CMD 26-H7.2

**Written Submission from the
Radiation Safety Institute of
Canada**

Application to refurbish Pickering Nuclear
Generating Station and to renew licences
for the Pickering Nuclear Generating
Station and Waste Management Facility

Review of Ontario Power Generation's (OPG's) Application to Renew its CNSC Licence for the Pickering Nuclear Generating Station and Pickering Waste Facility

Figure 3 Waste Management Facility airborne particulates from stack monitor. As there have been no significant emissions and no reason to believe this will change, stack monitoring has been ended for this location as of 2024.

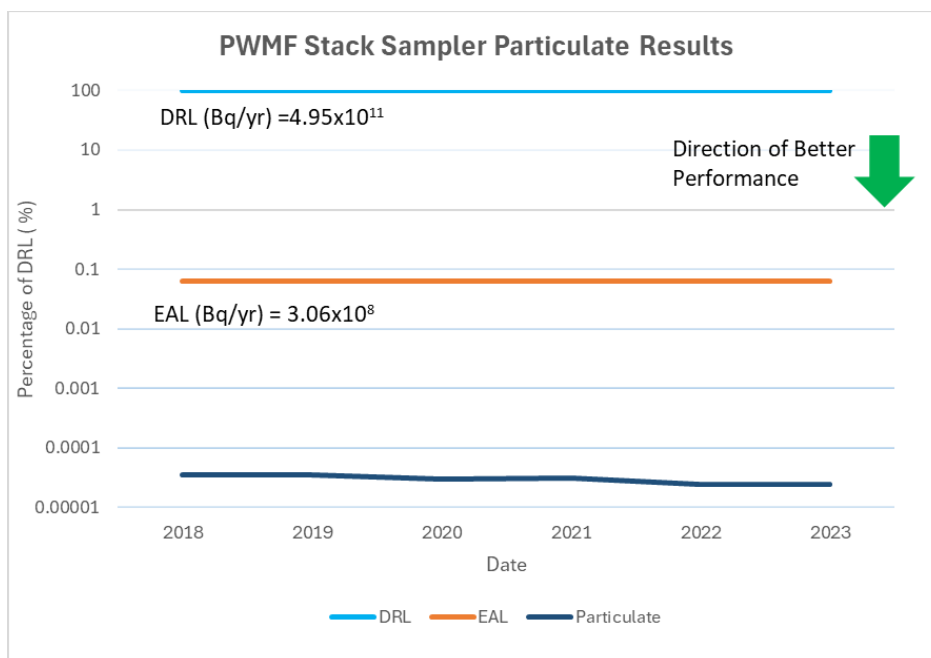
While the figures above show no annual exceedances, *“there were four monthly EAL exceedances for radiological emissions to water (for gross-beta gamma), the majority of which were attributed to sediment entrainment from the Lake or laboratory sample contamination. There was also one monthly DRL exceedance (for gross-beta gamma), which was attributed to the accumulation of lake sediment and not due to station operations. In addition, during the 2018 to 2024 licensing period, EAL for sewage gross beta-gamma was exceeded four times. These exceedances did not impact the health of the public or the environment and were investigated fully. Efforts continue to prevent recurrence”*.

Any monthly exceedance of an environmental action level (EAL) is of concern to RSIC. The statement “efforts continue to prevent recurrence” is *not* completely reassuring. **OPG should indicate what active steps they have taken or plan to take to prevent recurrence.**

Figure 4 Data from the application indicates that individual effective doses have been low. However, they also suggest that the OPG annual individual exposure control level is set too high to be of benefit in driving ALARA

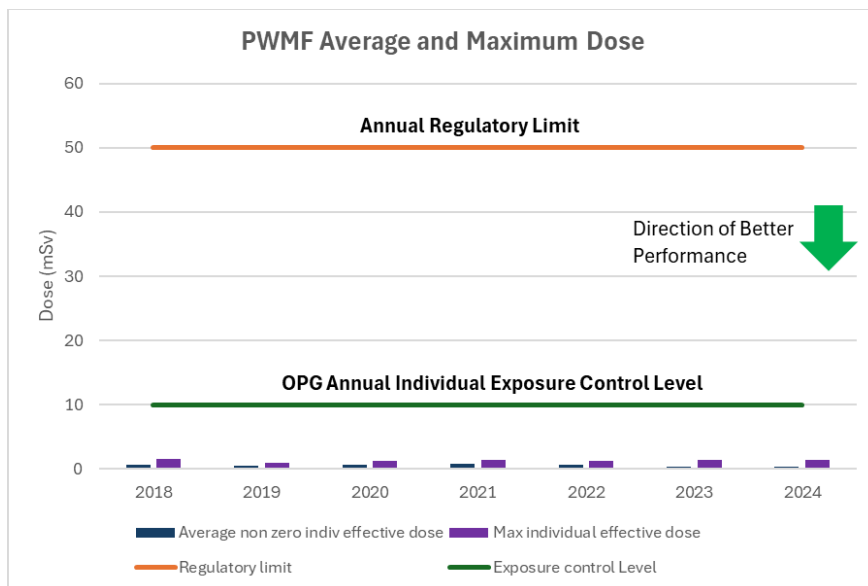
We suggest that OPG's Annual "Exposure Control Limit" be lowered, following the principle of "ALARA". Right now, it is set at 10 mSv/year, which we believe is too high to be useful in encouraging an ALARA approach to worker dose. Similar logic applies to controlling the annual dose for members of the public at the facility perimeter. OPG indicated their boundary dose limit was to maintain public doses at the site boundary to 1 mSv/y from external dose rates. We suggest that OPG should adjust their dose rate limits at the site boundary, to limit doses to members of the public to no more than 0.3 mSv/y, a common public dose constraint used internationally, recommended by the ICRP, and which is recognized by the CNSC, aiming to ensure that the total public dose remains well below the statutory limit. OPG's reported average dose rate in 2024 is below this, so adjusting their requirement should not adversely affect operations.

Figure 5 Pickering Nuclear Generating Station annual public dose

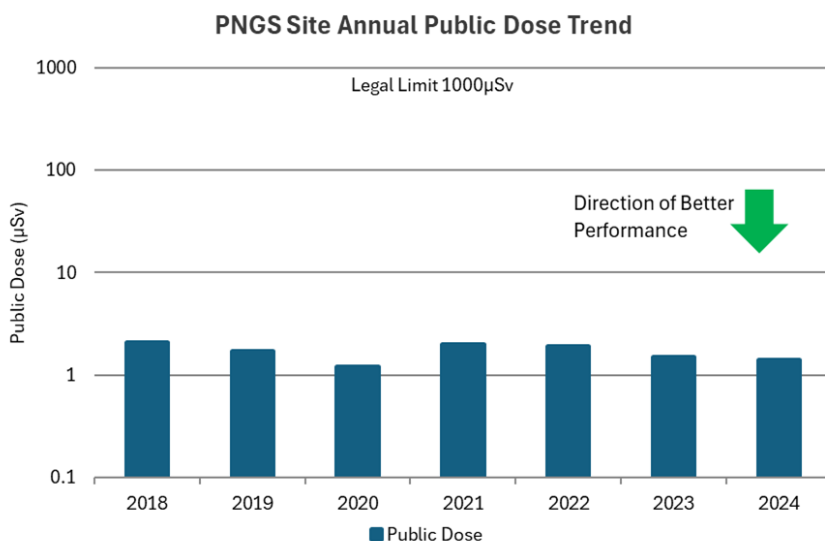
The values shown in Figure 5 above are reassuring that off-site air, water, fish, fruits, vegetables, animal feed, soil, etc. are not being significantly contaminated with radioactive materials. However, the values in this table are somewhat misleading, as they do not appear to include the potential dose to the most exposed member of the public from perimeter dose monitoring.

Figure 6 Pickering Nuclear Generating Station low and intermediate level radioactive waste produced annually

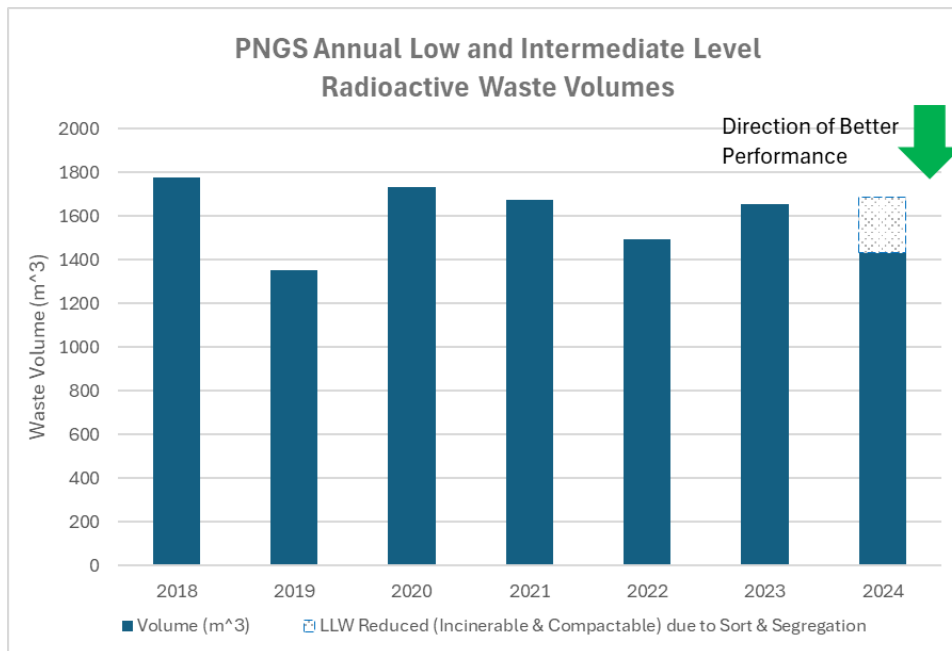
As seen in the figure above, the generating station produces a significant volume of waste. 2024 did see a reduction in overall volume due to a “sort and segregate” program. While a good thing, it would be appropriate for OPG to indicate the additional dose to workers required to carry out the sort and segregate procedures.
